## **Town of West Newbury**

**Request for Qualifications (RFQ)  
RFQ# 2023-WN-001**

# ***Dr. John C. Page Elementary School***

This Addendum #2 covers notes and questions from the briefing and tour, and additional questions received via email since then. Last day for questions is Friday May 12. Since the RFQ submittal deadline of May 19 is approaching, the goal going forward is to get responses back within 2 business days of questions.

Side B

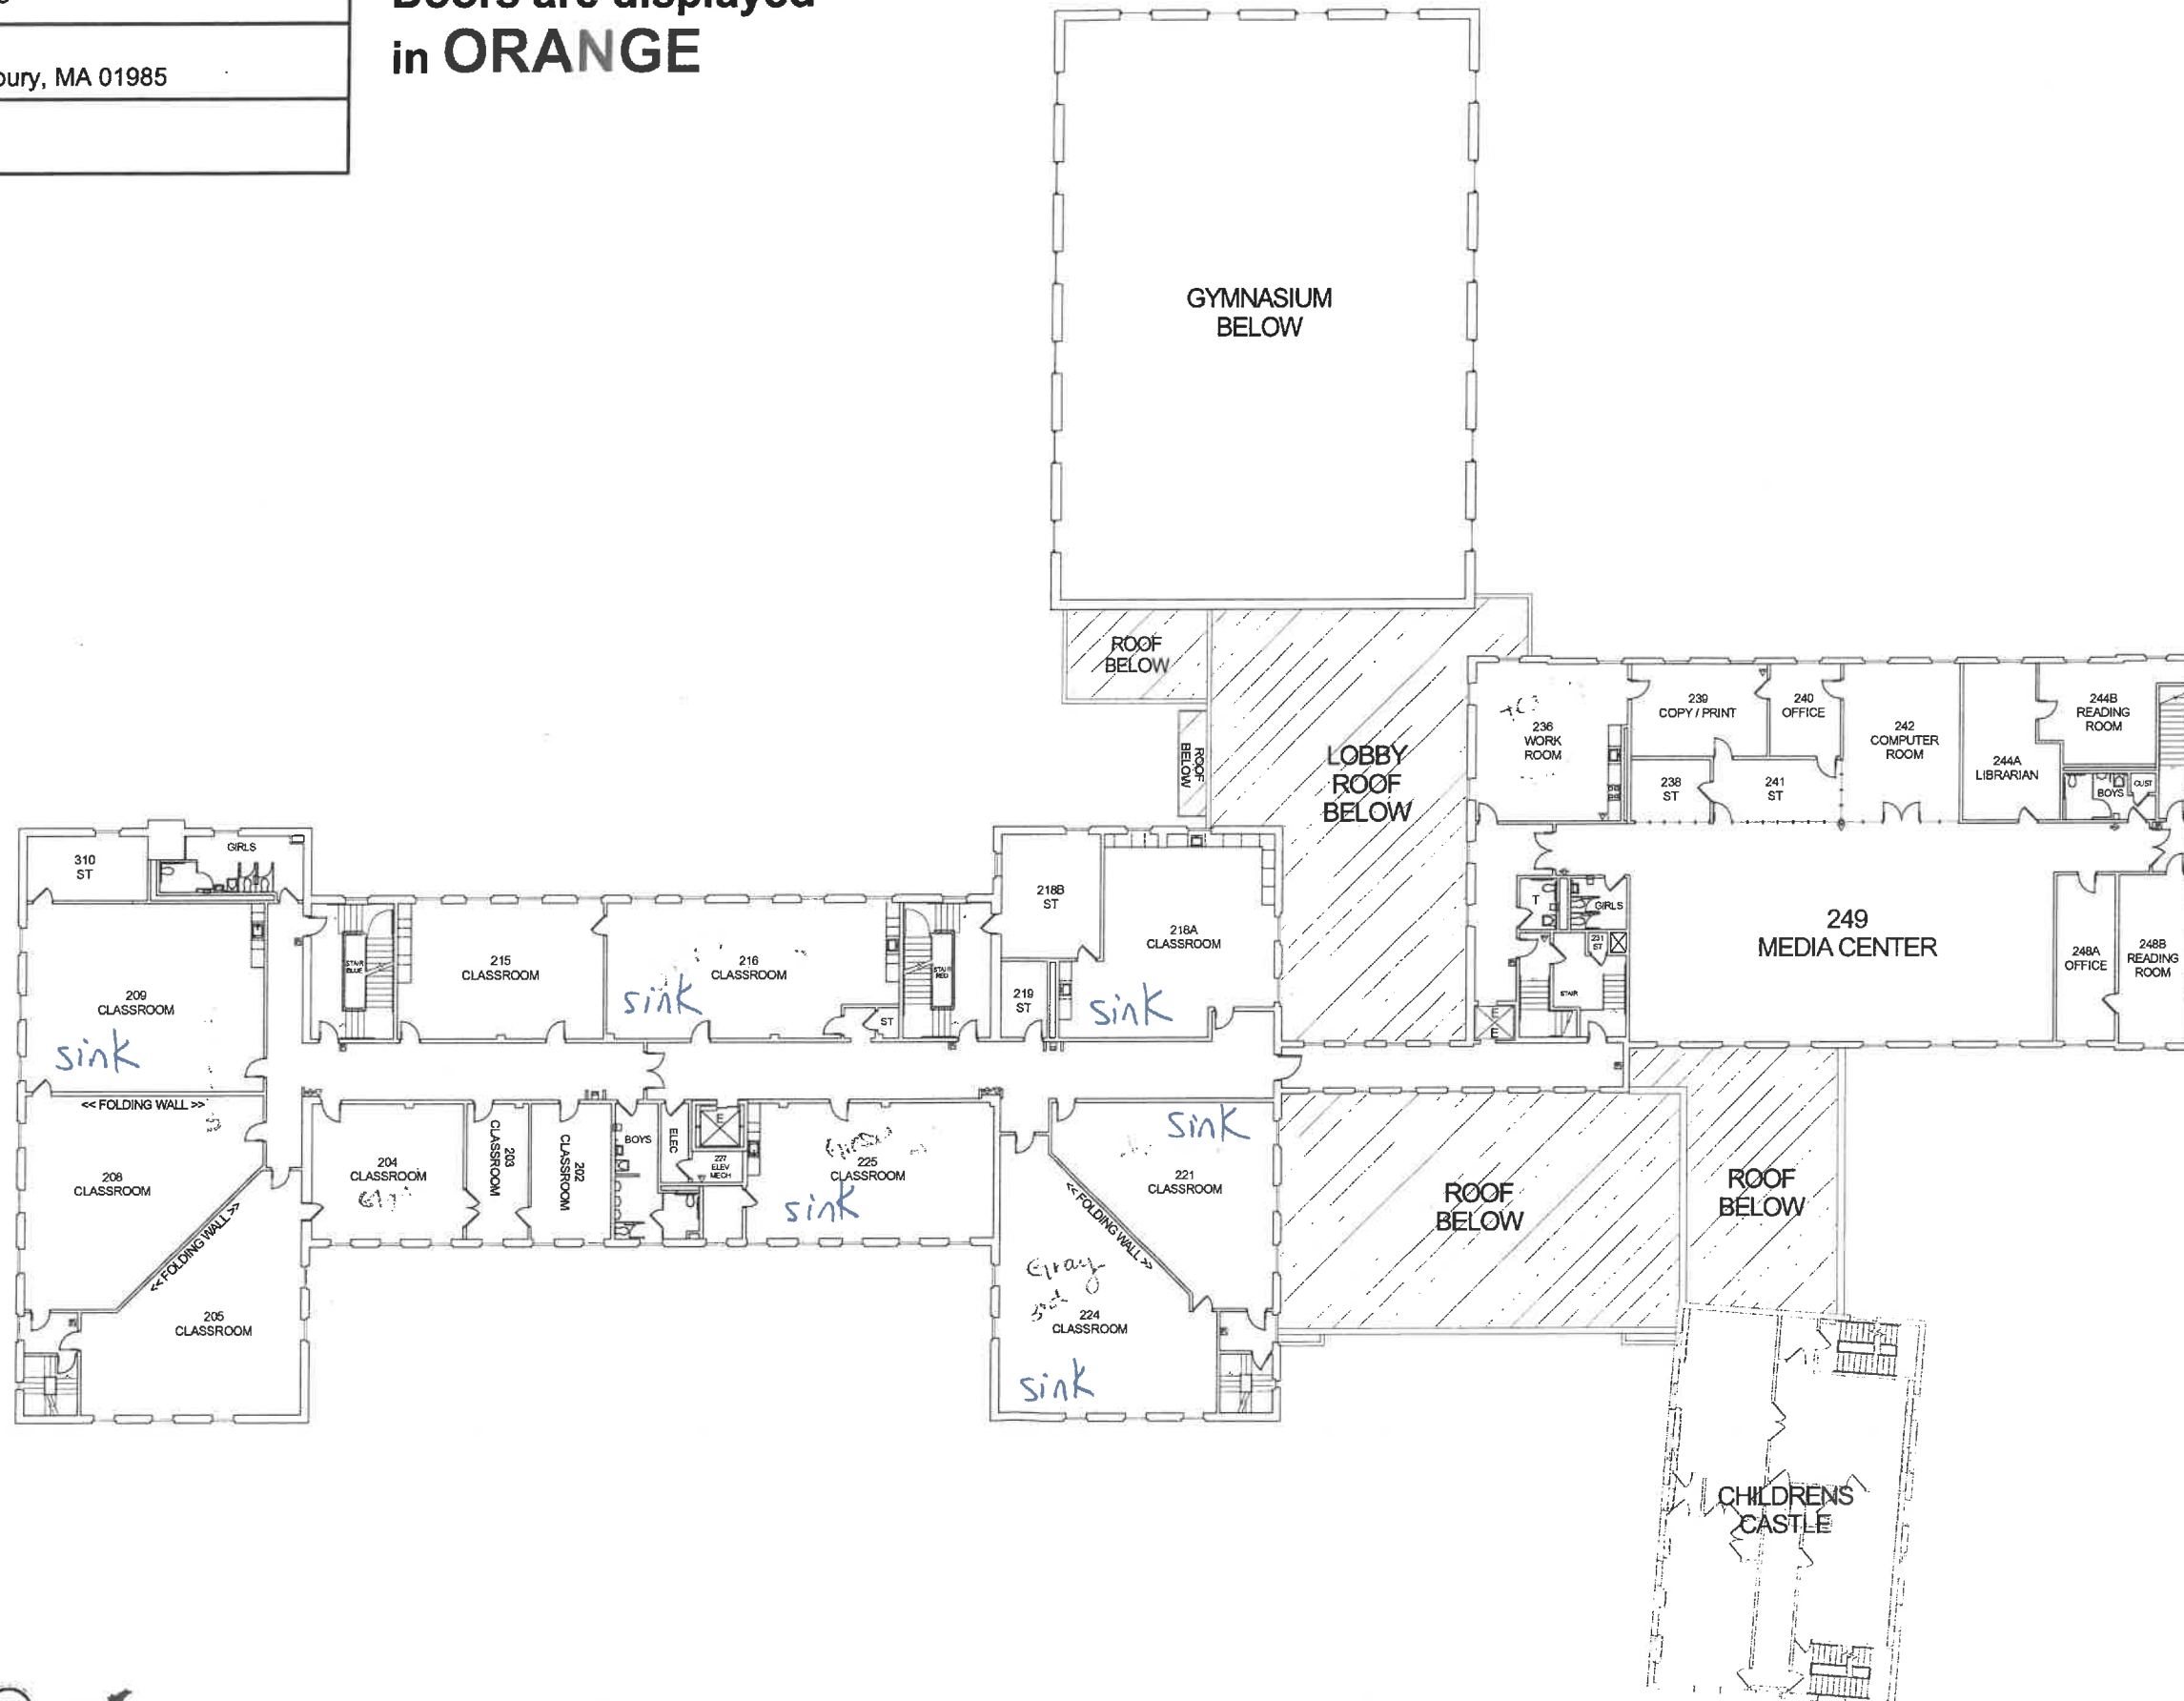
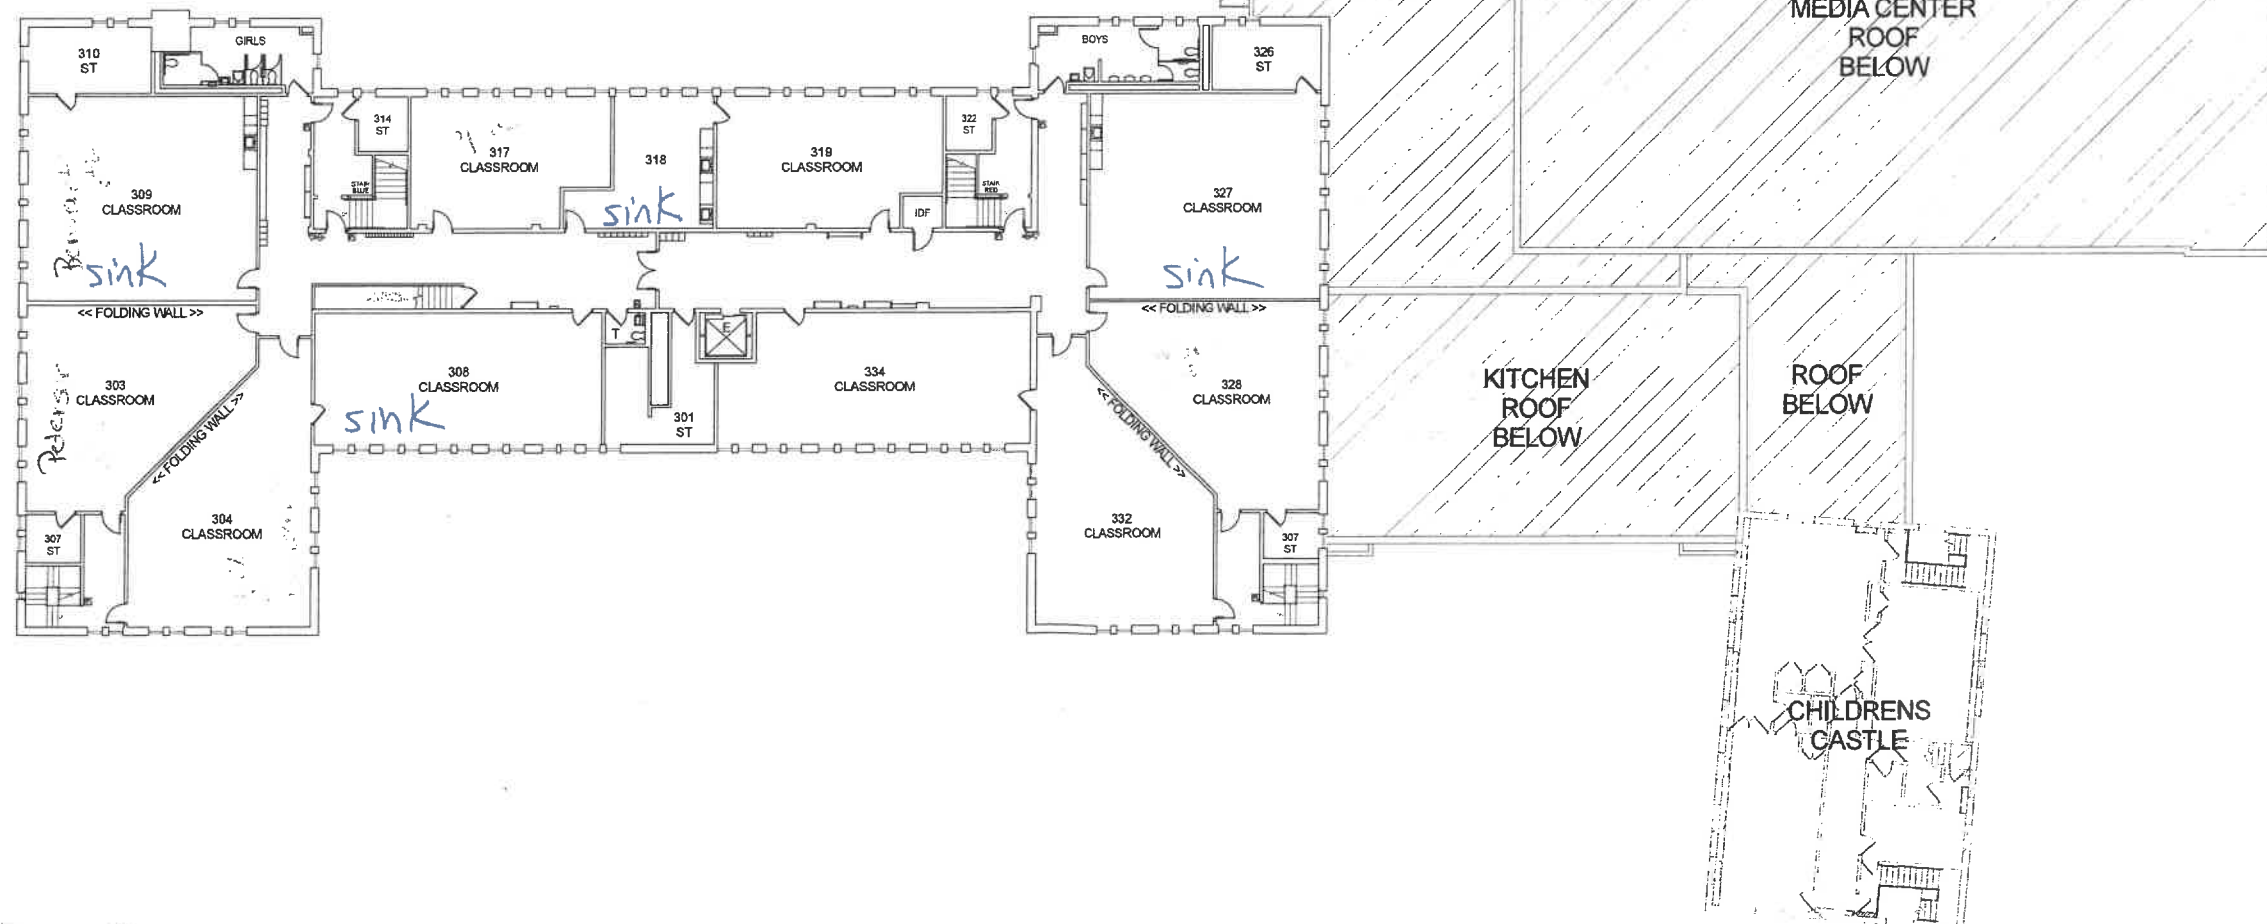
As photos were not available during the visit, can you share an egress plan of the building and/or any schematic plans as a reference?
